# Appendix D. Draft 2023 San Antonio Regional Flood Plan Comments

## **TWDB Draft Plan Comments**

RE: Texas Water Development Board Comments on Region 12 San Antonio RFPG's Draft Regional Flood Plan Contract No. 210792497

## **TWDB Comments on Region 12 San Antonio Regional Flood Planning Group's Draft Regional Flood Plan**

REGION 12 - MAP 16C - MODELING GAPS AND FLOOD MANAGEMENT EVALUATIONS EXISTING MODELS  
FINAL

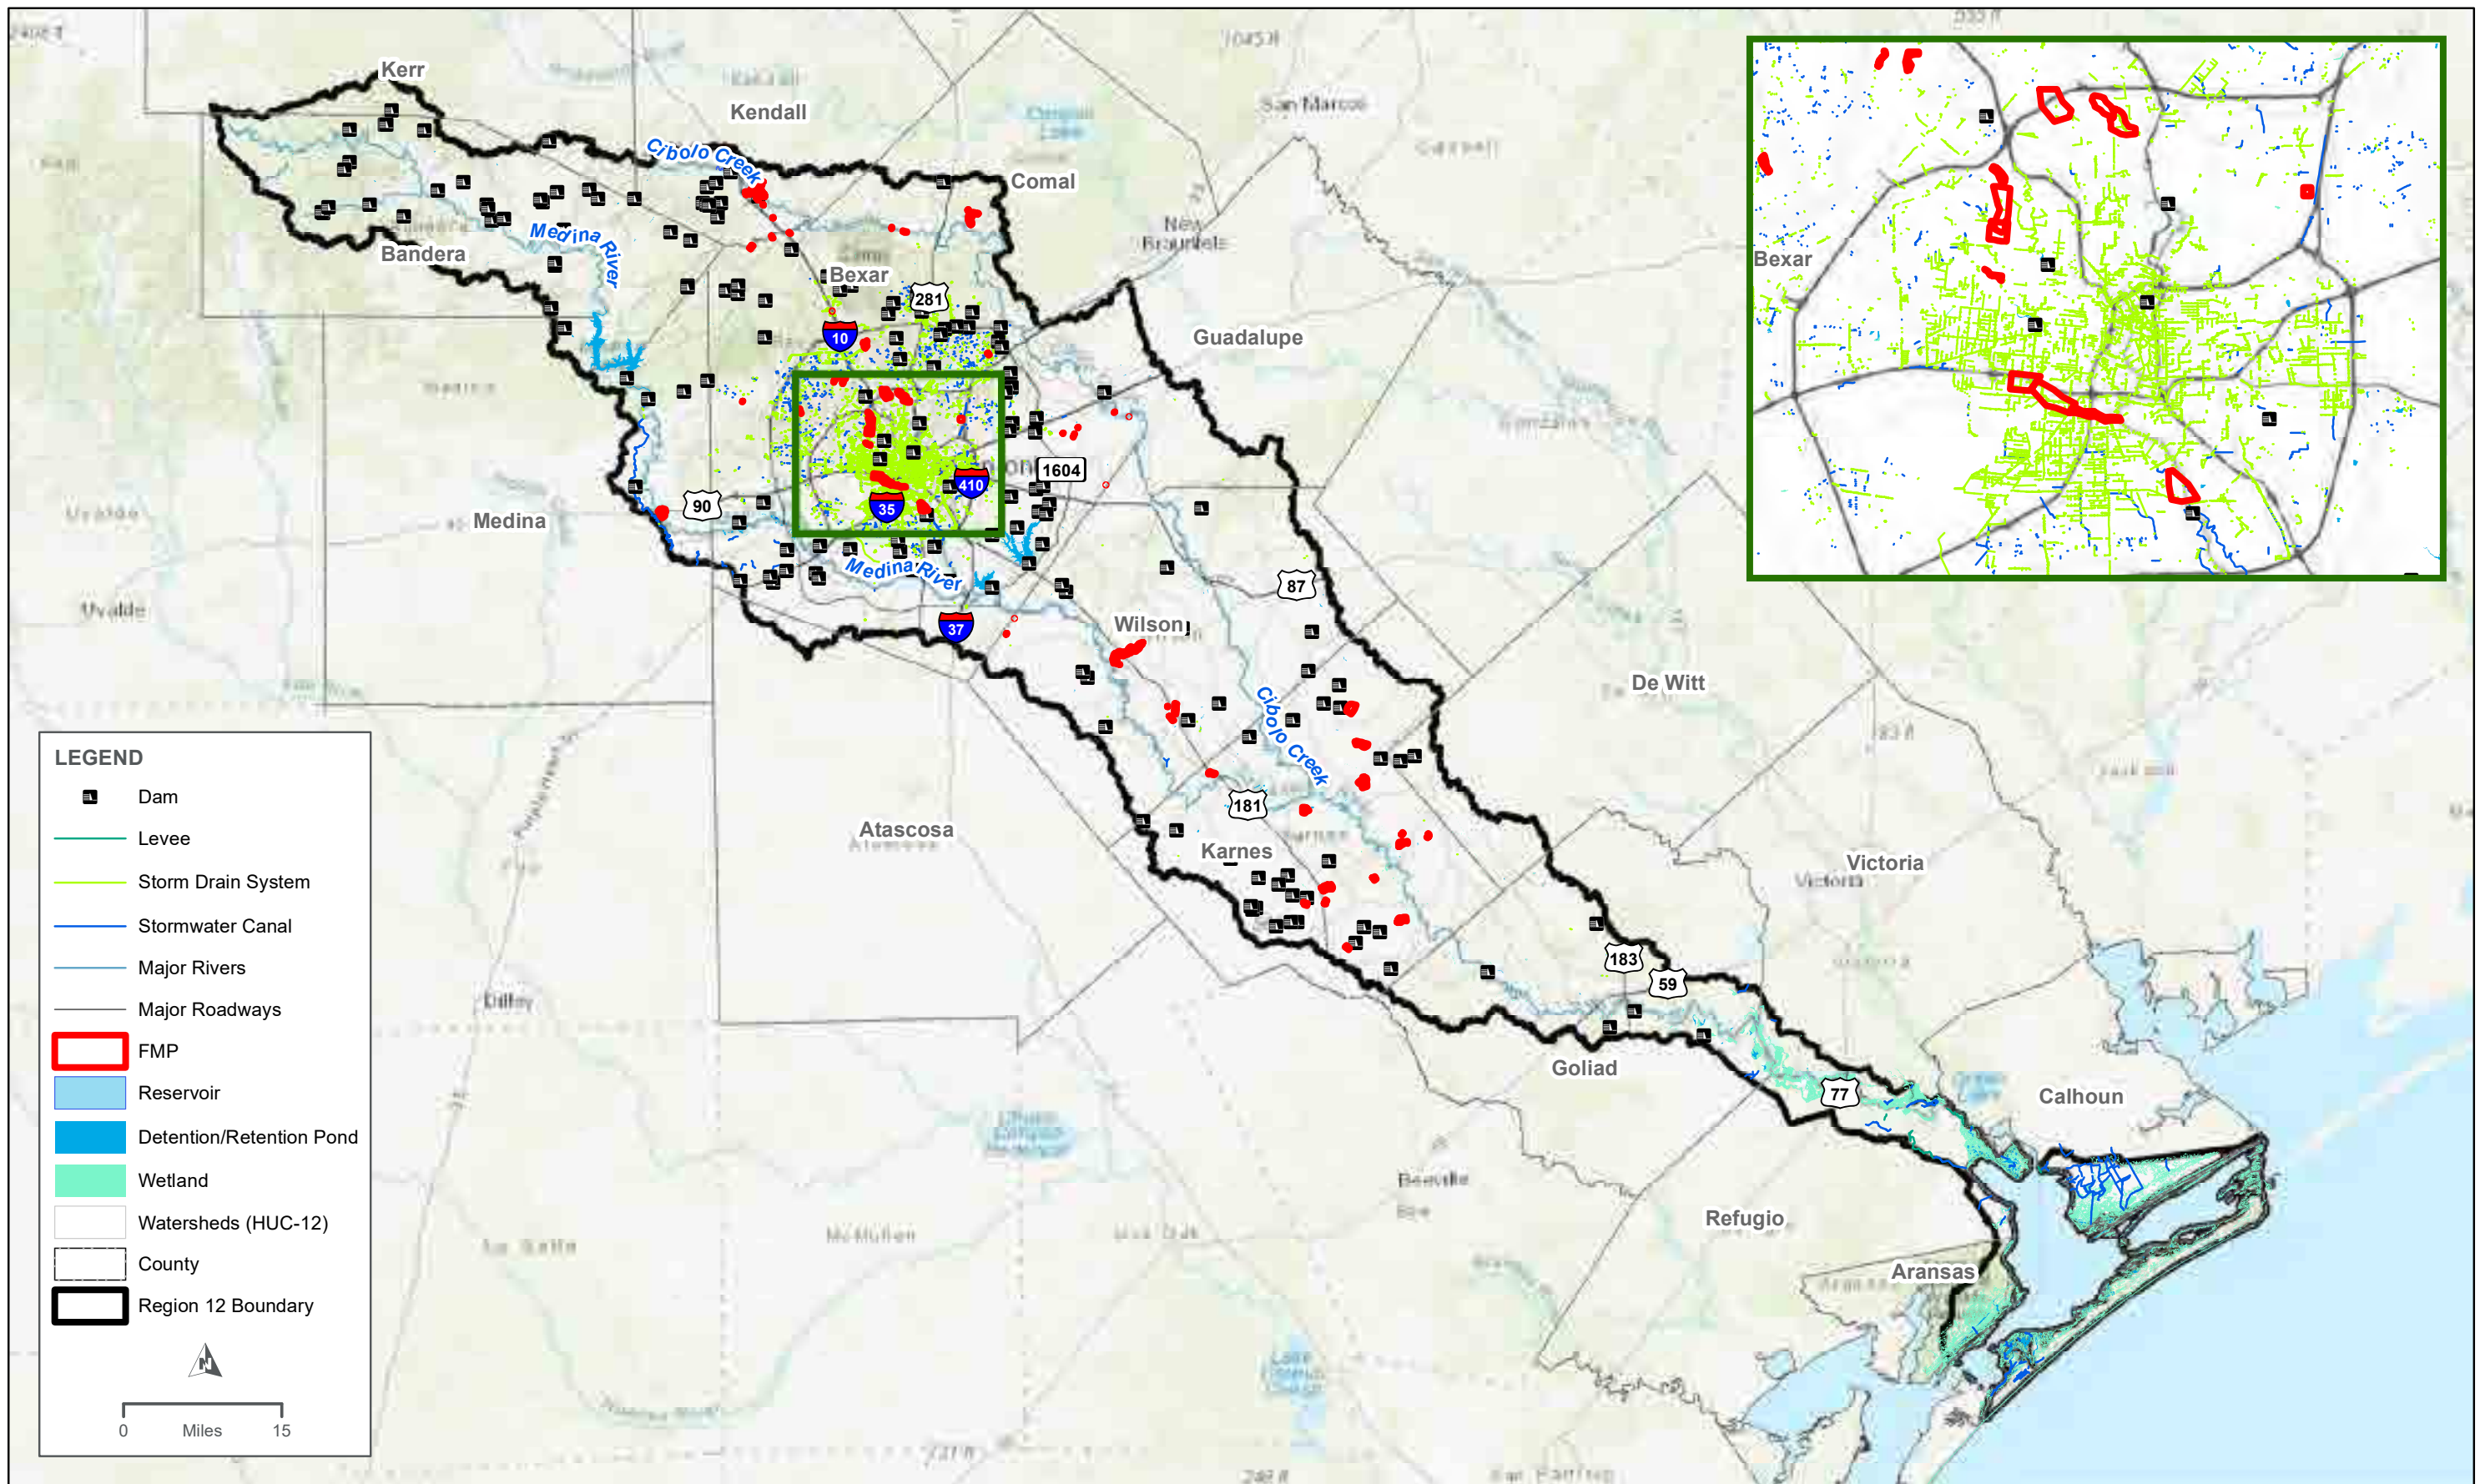
39. Flood Management Evaluation (Exhibit C Map 16):
  - a. Map 16 does not include region-wide FMEs. Please consider providing an additional map that would show all of the FMEs within the region.

Level 1	13	Plan	SOW Task 4B	13.Flood Management Evaluation (Exhibit C Map 16): Please indicate on the map whether the identified FME area is associated with a previously studied area that requires an update or if the identified study area does not have any existing or anticipated flood mapping, models, etc., and therefore requires an initial study. [31 TAC §361.38(m)].	Agree, will update.
